## Product Change Notice (PCN)

**PCN Number:** PCN-0450726R-01

**Product(s) Affected:** PJ-002AH-SMT-TR, PJ-002BH-SMT-TR

Current version	New version
Outlook	 <p>housing</p>	 <p>housing</p>
	 <p>pin# 3</p>	 <p>pin# 3</p>

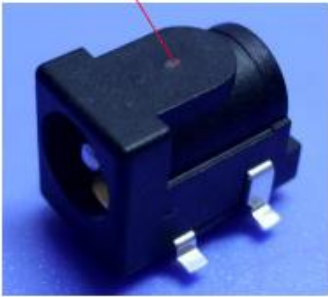
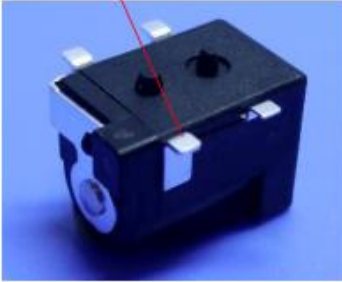
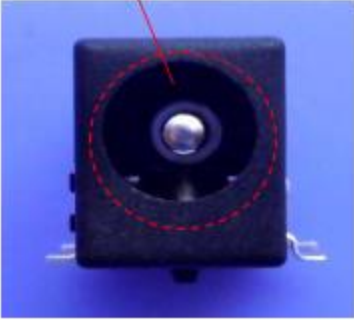
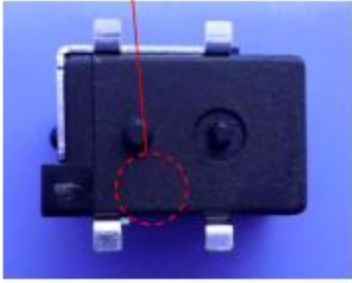
**Reason(s) for Change:** existing plastic housing and pin 3 molds cannot maintain efficient production.

**Description of Change:** to ensure quality and production efficiency, new mold development is in process. Aesthetic changes as shown below. Electrical structure and function remain unchanged.

Front	<p>jack hole without chamfer</p> 	<p>jack hole with chamfer</p> 
Bottom	<p>without cave marking</p> 	<p>cave marking location</p>
